### Proposed Revisions to a Standard Plans Index

Index Number: 654-001

Index Title: Rectangular Rapid Flashing Beacon Assembly

LAST REVISION	11/01/23	DESCRIPTION:		FY 2023-24 STANDARD PLANS	RECTANGULAR RAPID FLASHING BEACON ASSEMBLY	INDEX 654-001	SHEET 1 of 2
---------------	----------	--------------	--	------------------------------	--	------------------	-----------------

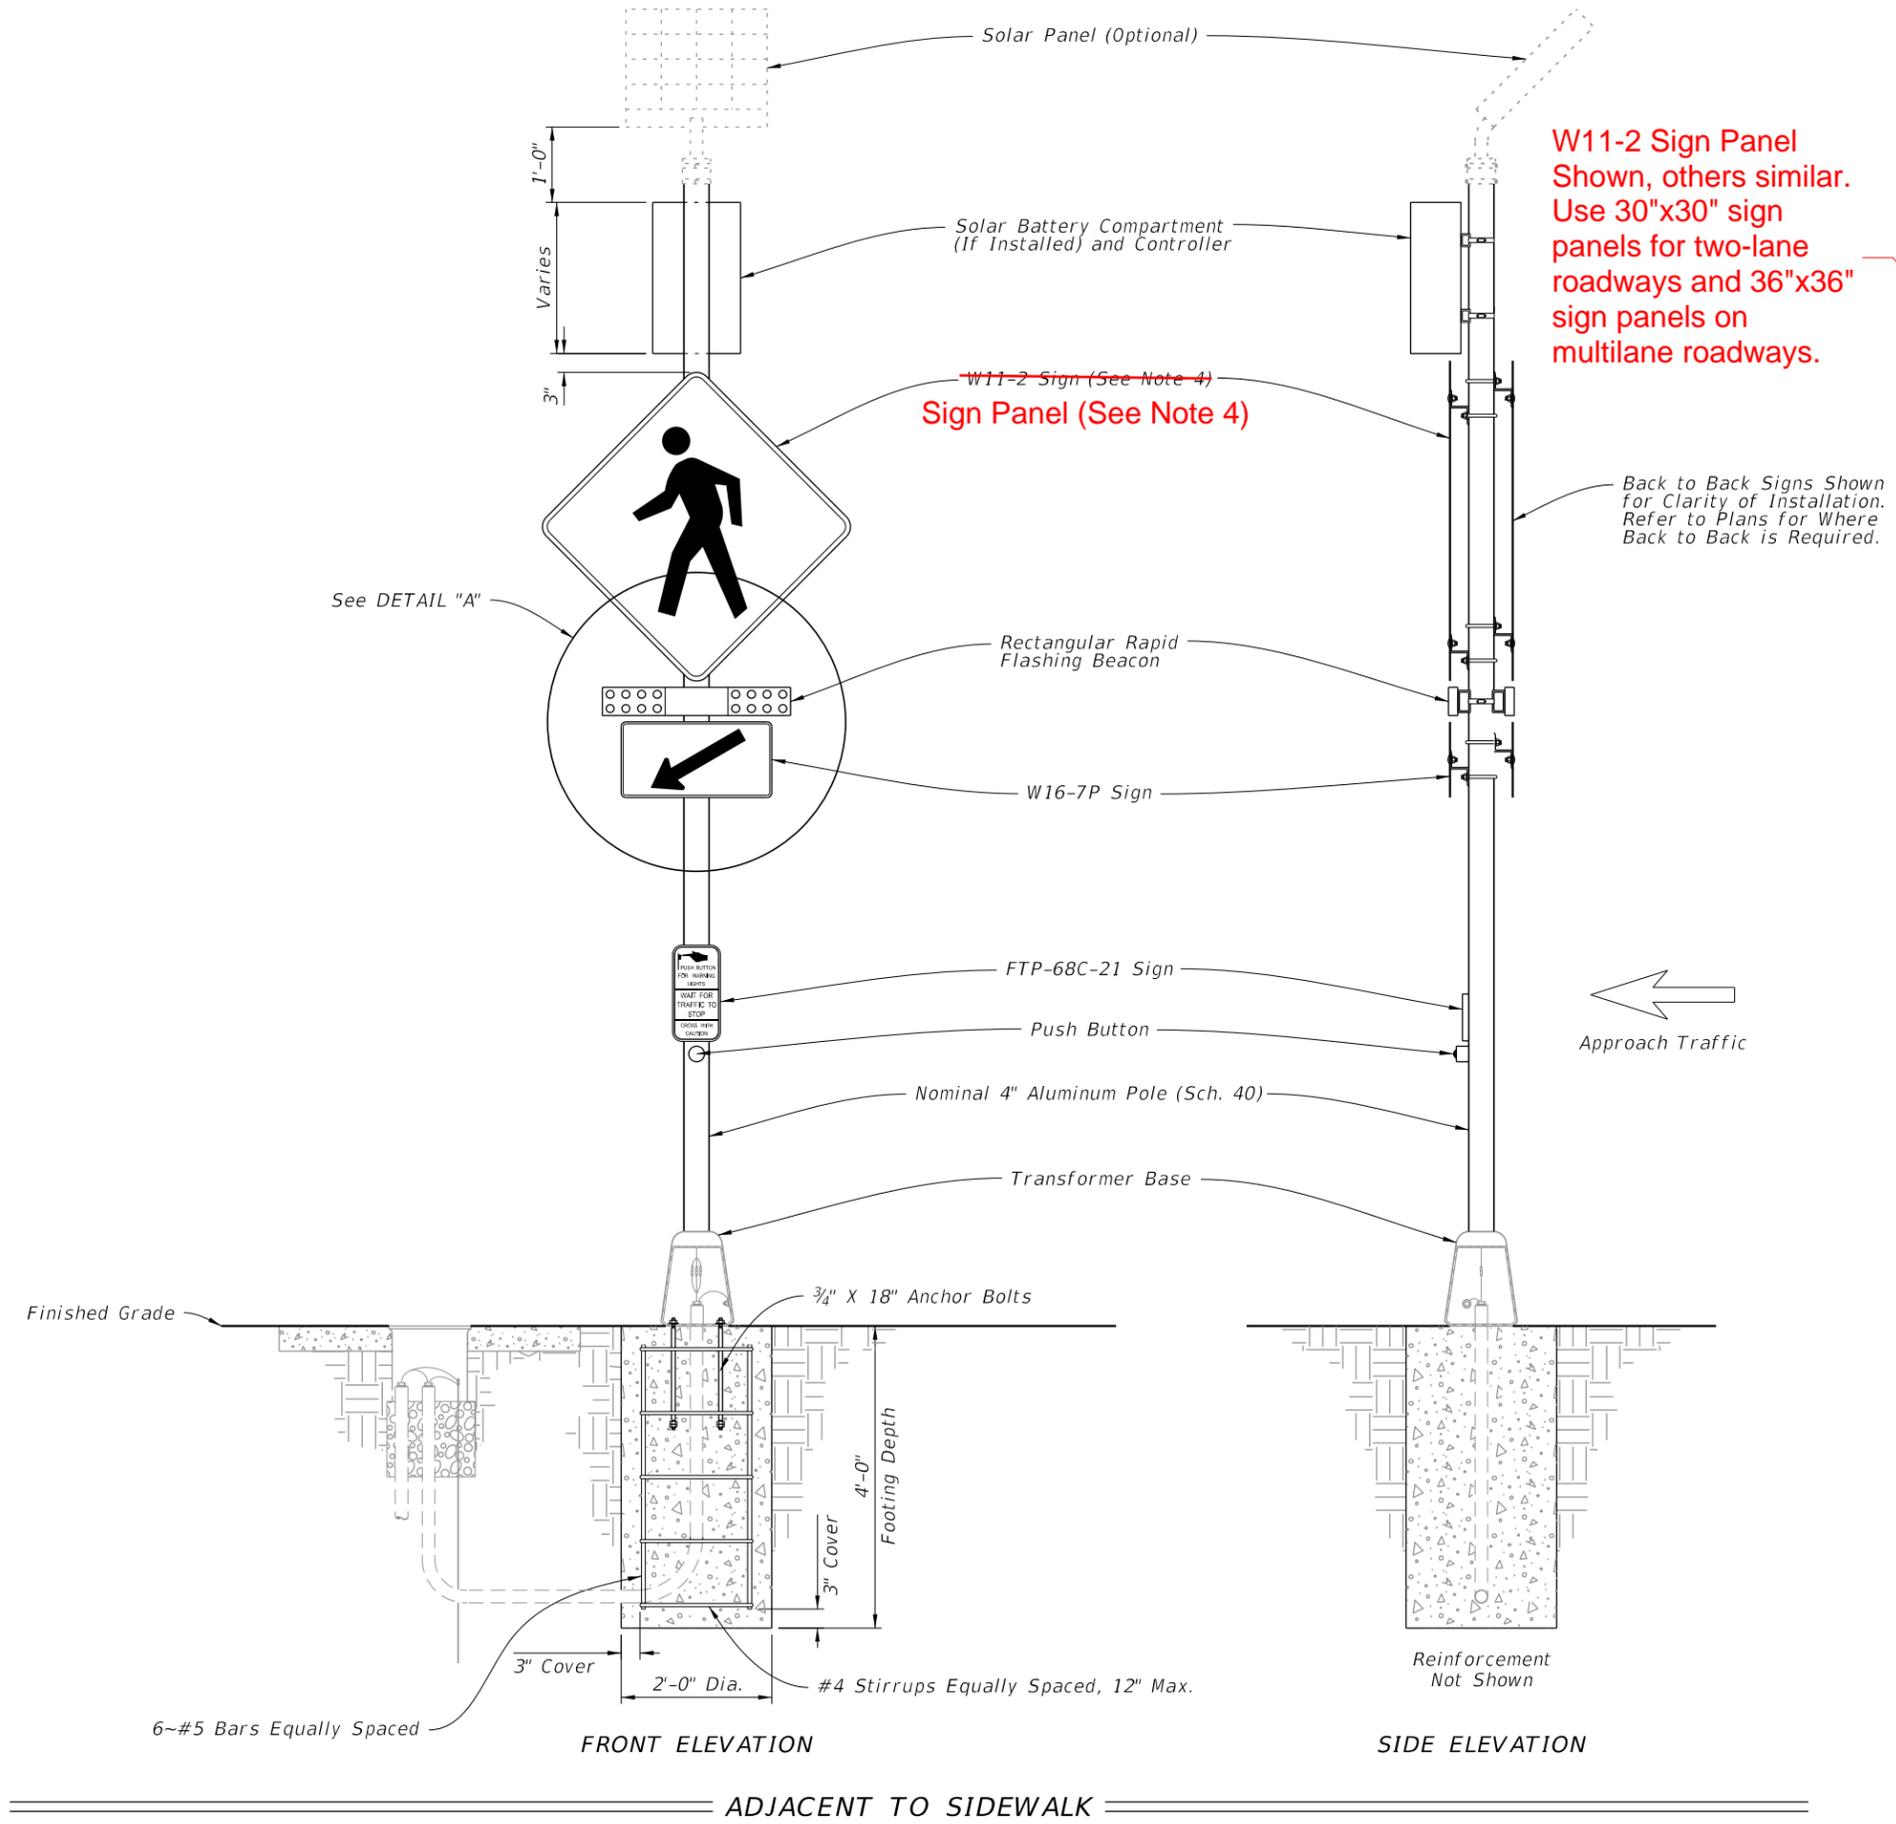
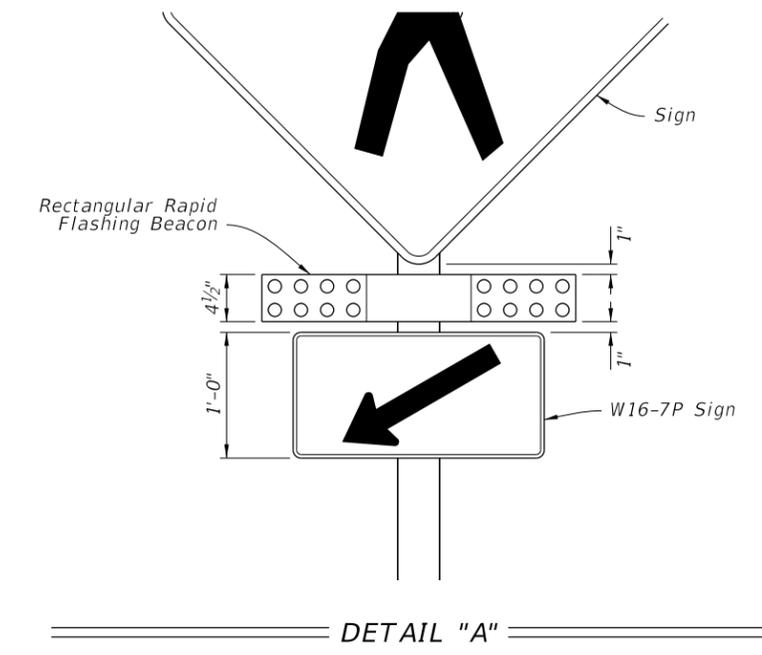
Sheet 1: Updated Note 4 to "W11-2 Sign Panel Shown, others similar. Use 30"x30" sign panels for two-lane roadways and 36"x36" sign panels on multi-lane roadways. Updated callout to "Sign Panel (See Note 4)". Added Note 12, "In lieu of footing design shown, a Spread Footing may be used in accordance with index 700-120."

W11-2 Sign Panel  
Shown, others similar.  
Use 30"x30" sign  
panels for two-lane  
roadways and 36"x36"  
sign panels on  
multilane roadways.

2. Install the RRFB in pairs, one on either side of approach traffic.
  3. Install controller on the backside of post from approach traffic.
  4. ~~Install a 30" X 30" W11-2 sign on two-lane roadways and a 36" X 36" W11-2 sign for multilane roadways.~~

**12. In lieu of footing design shown, a Spread Footing may be used in accordance with Index 700-120.**

LAST REVISION <del>11/01/21</del> 11/01/23	DESCRIPTION: 11/01/23		FY 2023-24 STANDARD PLANS	RECTANGULAR RAPID FLASHING BEACON ASSEMBLY	INDEX 654-001	SHEET 2 of 2
--	--------------------------	--	------------------------------	--	------------------	-----------------

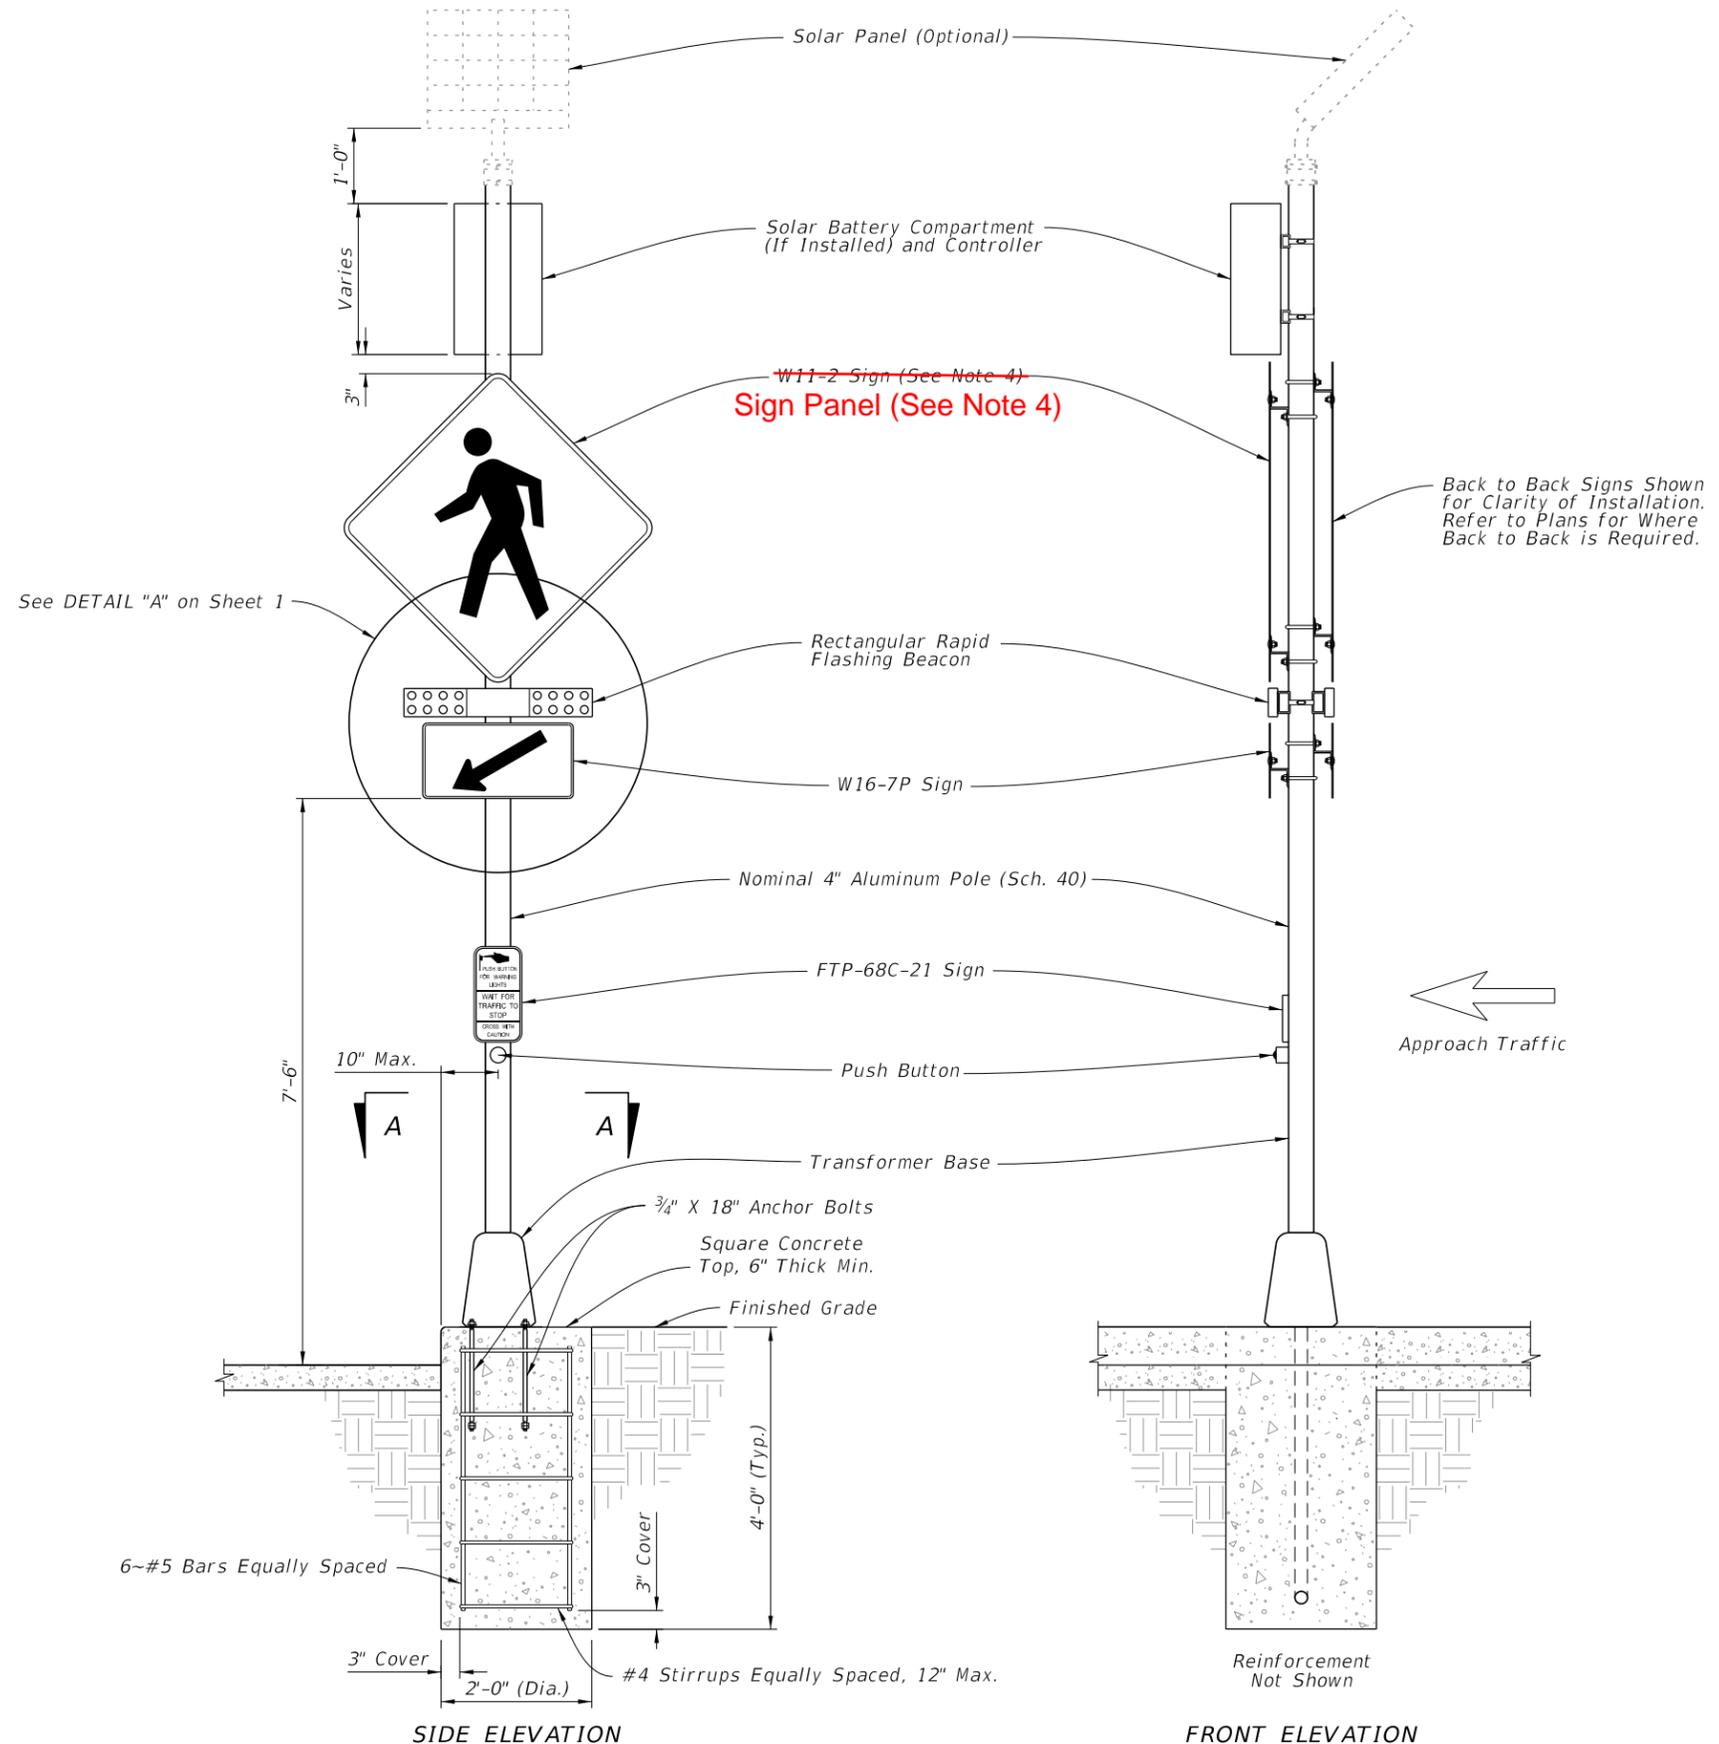
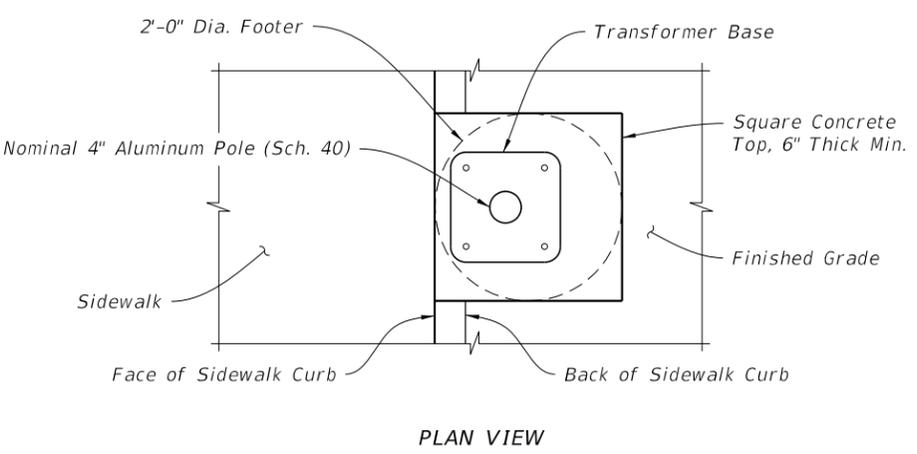
Sheet 2: Updated callout to "Sign Panel (See Note 4)".
